**Appendix III of RNTPC
Paper No. A/YL-PH/768B**

**Detailed Comments of the Chief Town Planner/Urban Design and Landscape,
Planning Department (CTP/UD&L, PlanD)**

**Appendix IV of RNTPC
Paper No. A/YL-PH/768B**

**Detailed Comments of the Chief Engineer/Mainland North, Drainage Services
Department (CE/MN, DSD)**

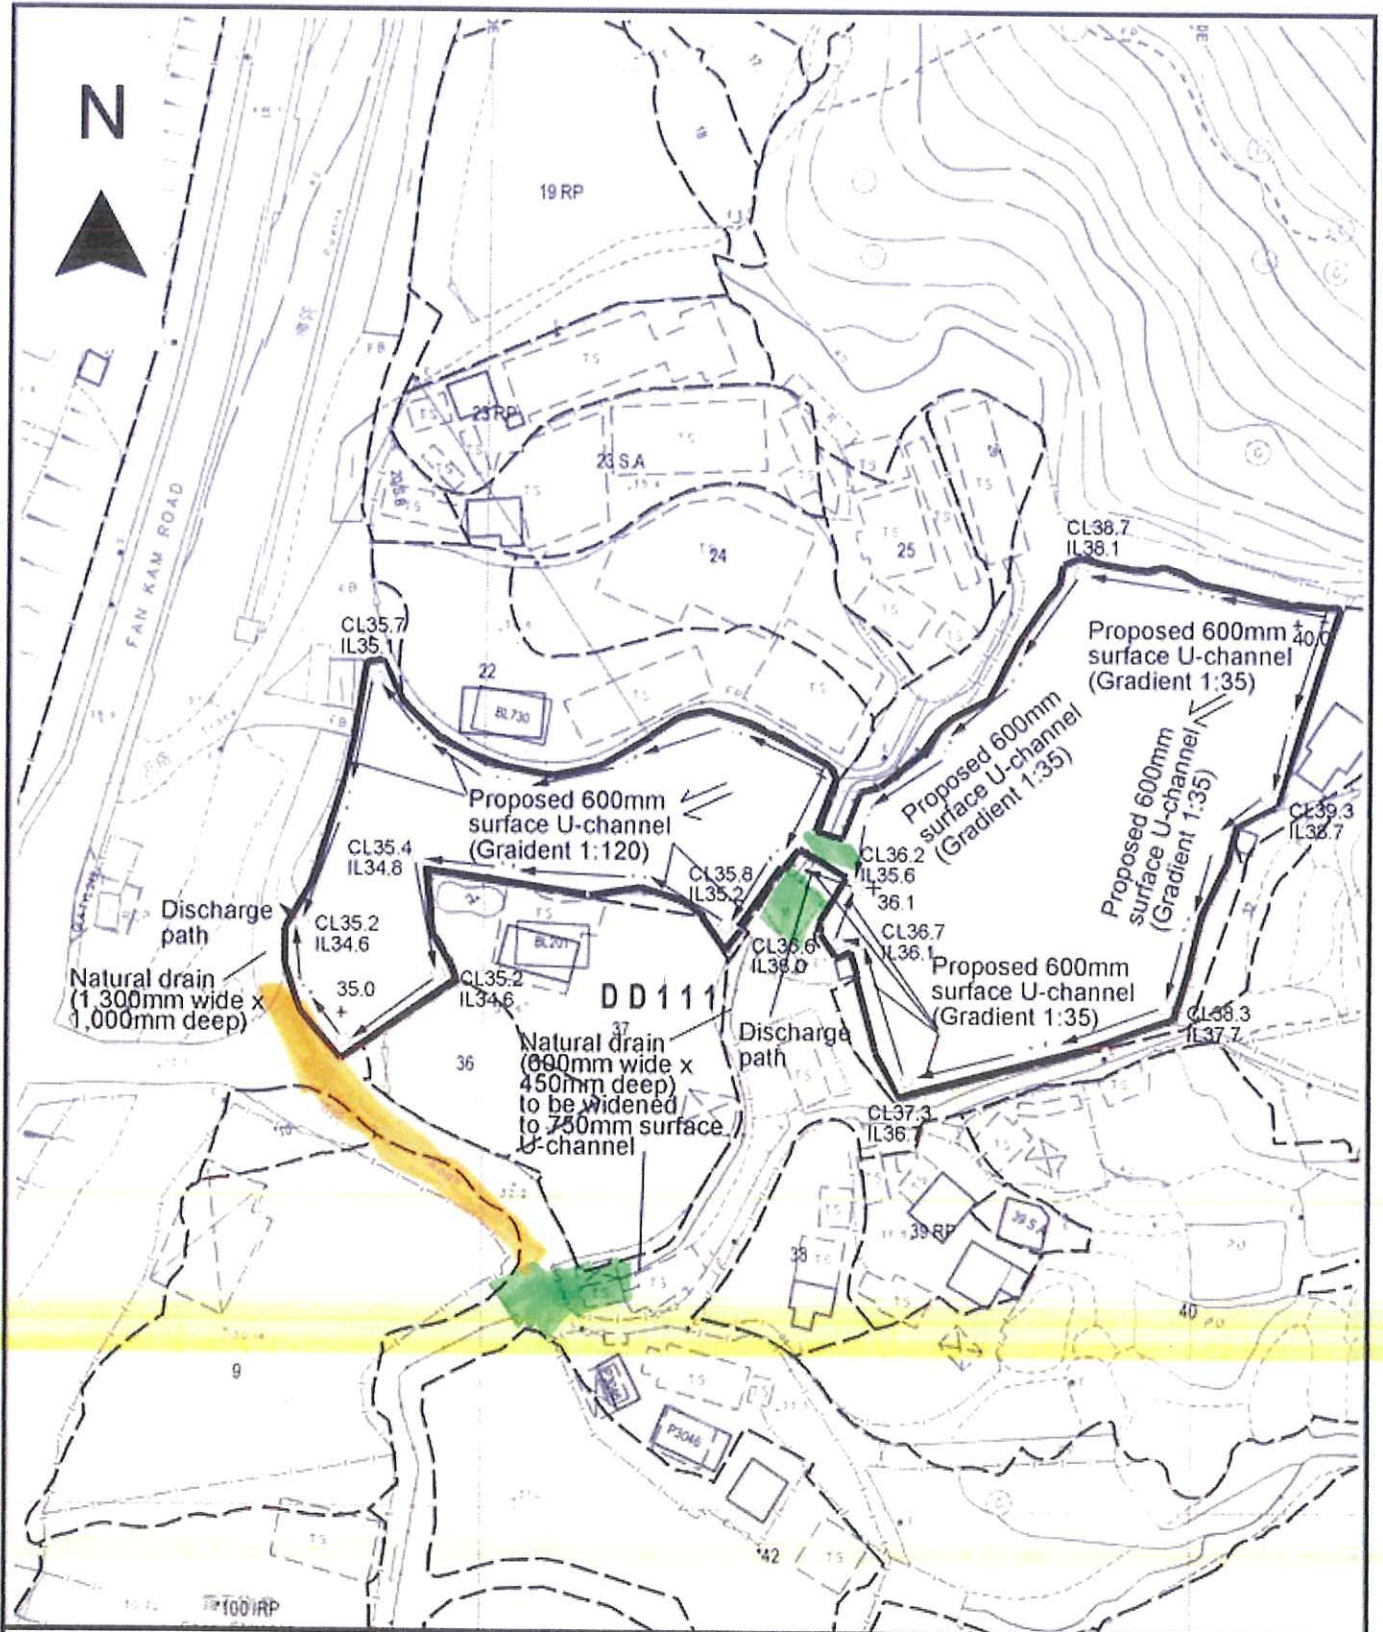
The submitted landscape plan is considered not acceptable from landscape planning perspective and the comments are as below:

- (i) The proposed trees should be planted at-grade with open bottom for drainage purpose. Please be reminded that all trees should be planted in planting area of min. 1m (W) x 1m (L) x 1.2m (soil depth) and supported with tree stakes initially for healthy establishment.

- (ii) Noted from the proposed drainage plan, U-channel is proposed along the site boundary. Applicant should provide a typical section showing dimensions and relationship between the U-channel and proposed trees. Please be reminded that a minimum 1m clearance should be maintained between the trees and the U-channel.

- (iii) Tree protective measures such as kerb/wheel stoppers/bollards at min. distance of 1m from the tree to guard against potential damage to the trees from vehicular movements should be indicated on plan and installed.

Catchment Plan

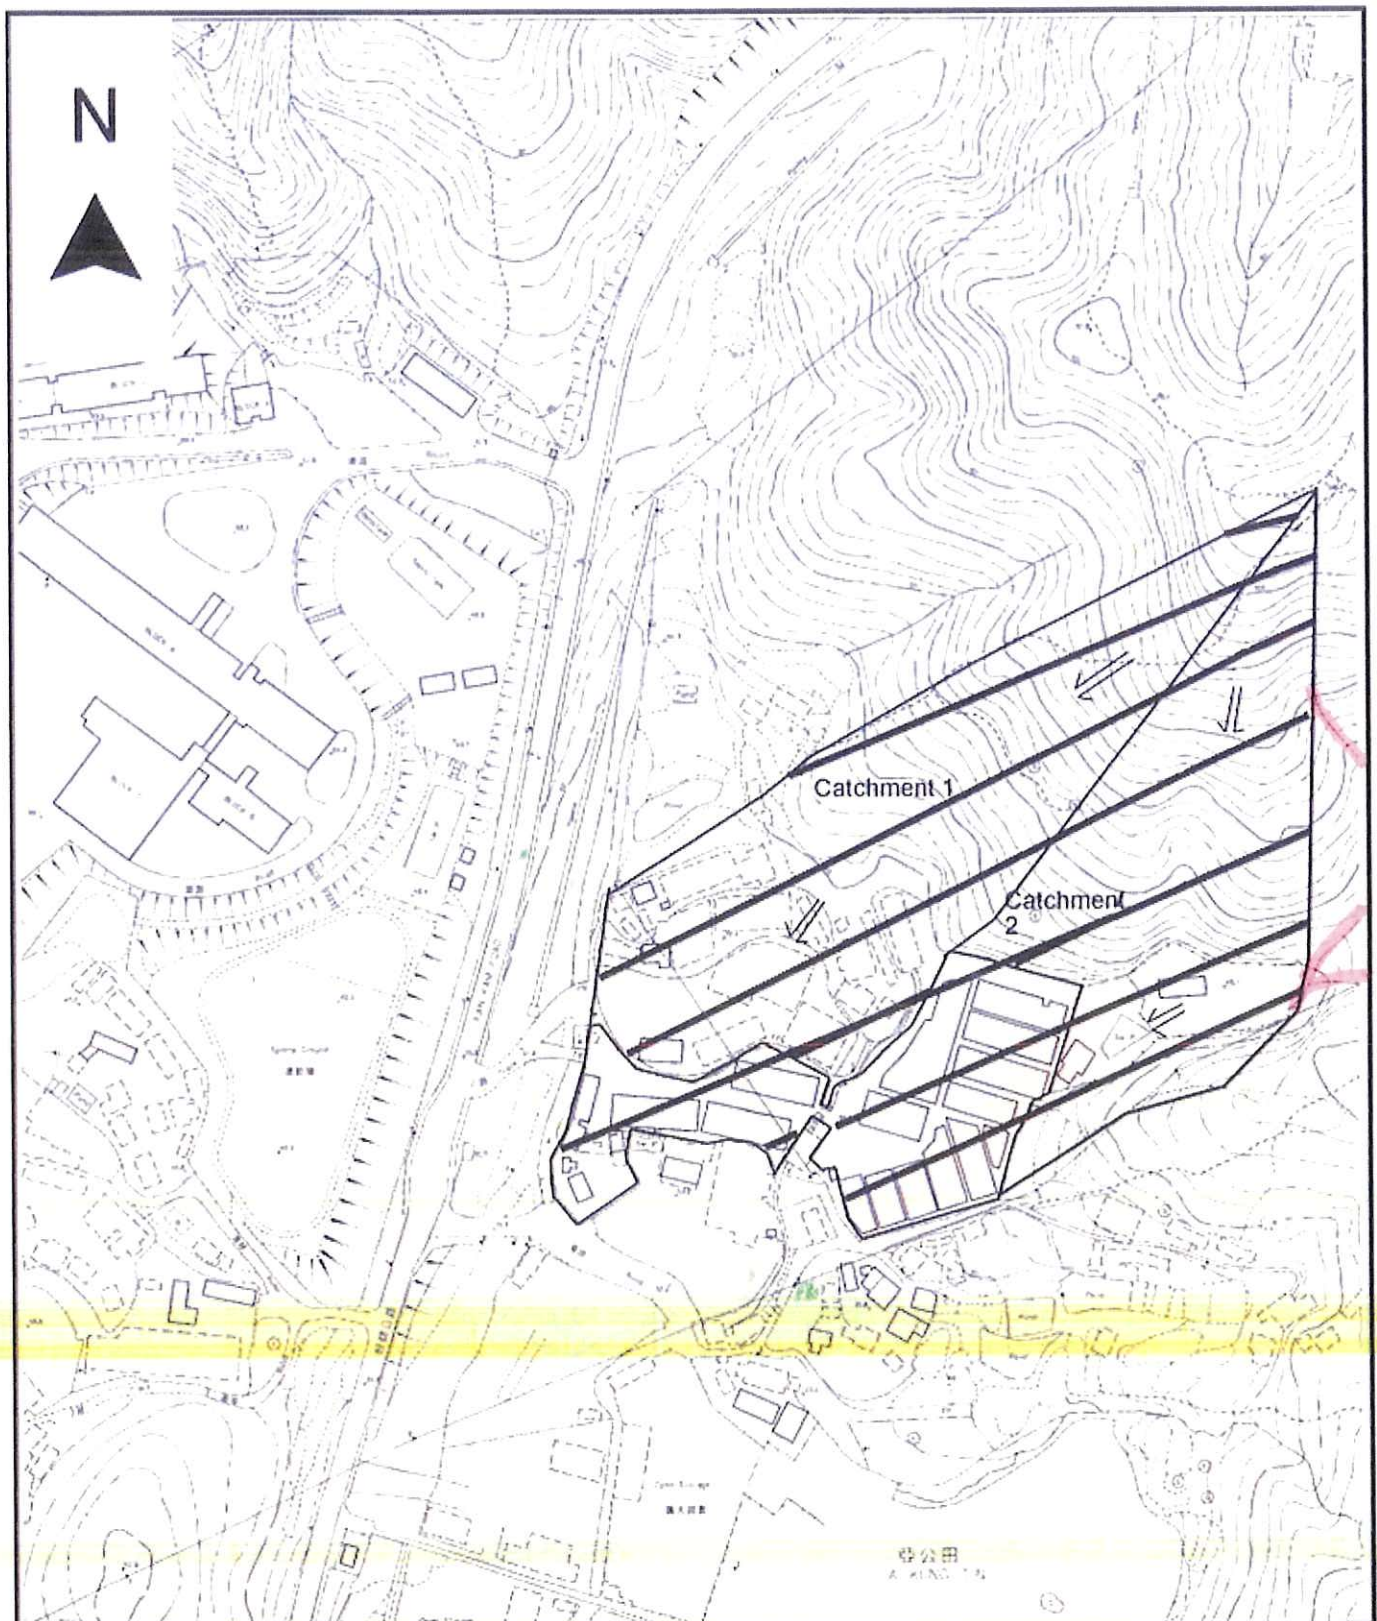
- (i) The corresponding Chart for channel design should be attached for reference.
- (ii) The invert level of the U-channel in catchment is higher than the ground level at the north of the Site. The level of the channel should be low enough to intercept overland flow. Please review.

- (iii) There is a few streams (highlighted in pink in the attachment) running at the east of the hatched Catchment 2 area which are discharging into the same downstream area. Therefore, the area of Catchment 2 is underestimated. Please review.

- (iv) There are a number of structures (highlighted in green in the attachment) that may constraint the size of the existing 600mm wide x 400mm deep natural drain. The applicant must check all these critical sections so that no bottleneck will be created.

- (v) The applicant should also demonstrate the deck over drain (highlighted in orange) of downstream of Catchment 1 is at least the same size of the upstream natural drain (1300mm wide x 1000mm deep).
